**Technical Service Bulletin:**  
TSB160088

**New Intake and Exhaust Rocker Levers**

- ISX (All 15 Liter Versions)
- QSX (All 15 Liter Versions)
- X15 (All Versions)

Figure 1, Existing Exhaust Rocker Lever With Bronze Pin.

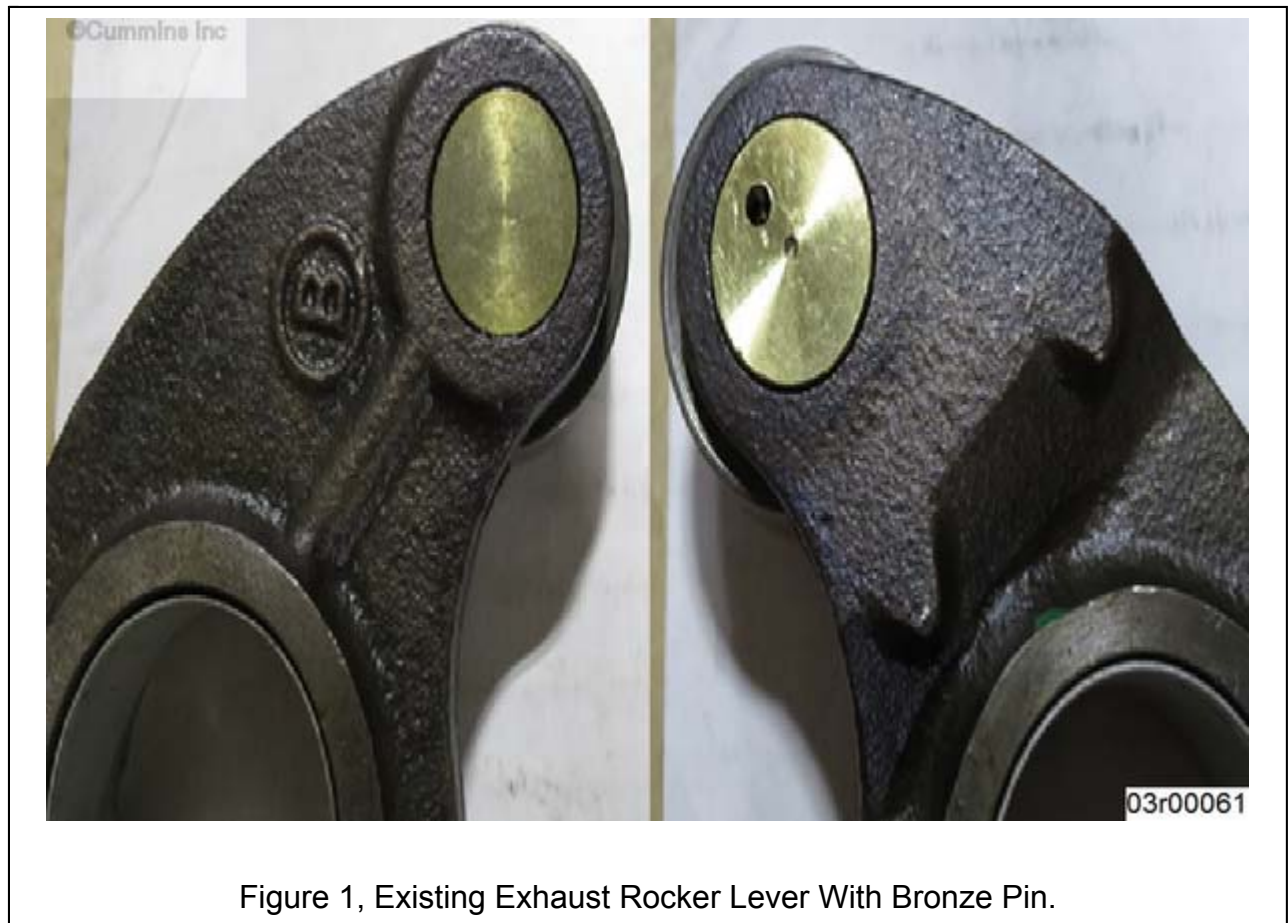
This document announces the release of new intake and exhaust rocker levers with cam follower roller pin changes.

The changes to the roller pins and lubricating oil feed in the new rocker levers improve robustness against corrosion and debris related damage in the roller to roller pin joint.

Existing rocker lever design has:

- A bronze colored, solid pin. See Figure 1 below.

Figure 5, Pin Protrusion Specification.

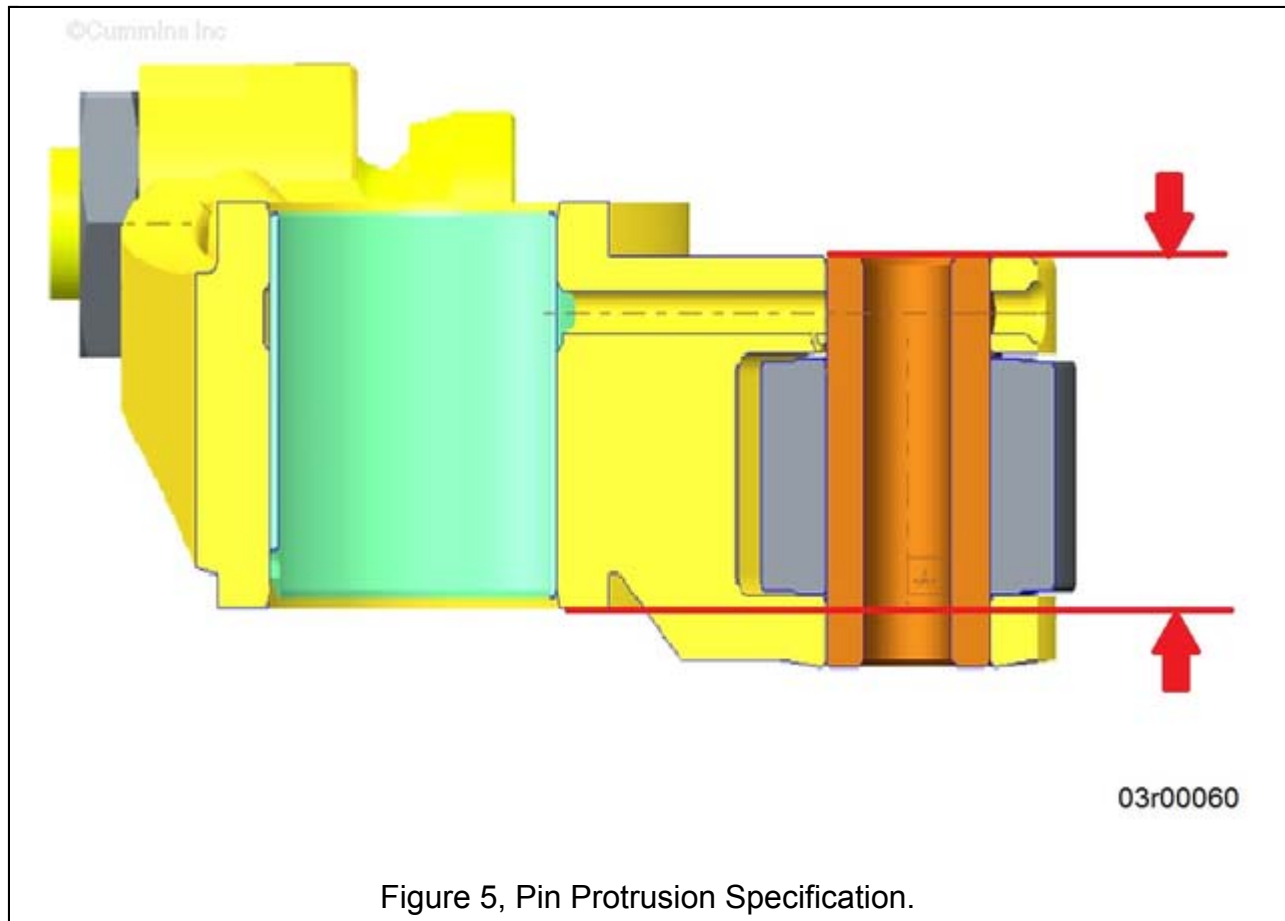
**Pin Protrusion:** Since the introduction of the new pin design, in some cases, it has been identified to have the cam follower pin to be protruding out of the side of the rocker lever cast surface. This condition is often associated with a pin and roller seizure issue (See Figure 3 below). Visual appearance condition does also exist on new production parts and is considered normal. Graphics below provide an anticipated range of pin position (See Figure 4 below). Amount of pin that protrudes may vary due to normal manufacturing processes. If rocker levers are found to exceed specifications provided, rocker lever may need replaced.

The pin location is determined by measuring the distance from the face of the cam follower pin from the side of the rocker lever that has the thick cast leg (it is also the surface that is on the same side of the lever as the adjusting screw) to the opposite thrust face of the rocker lever. The specification limit for this distance is 25.25 +/- 0.3 mm.
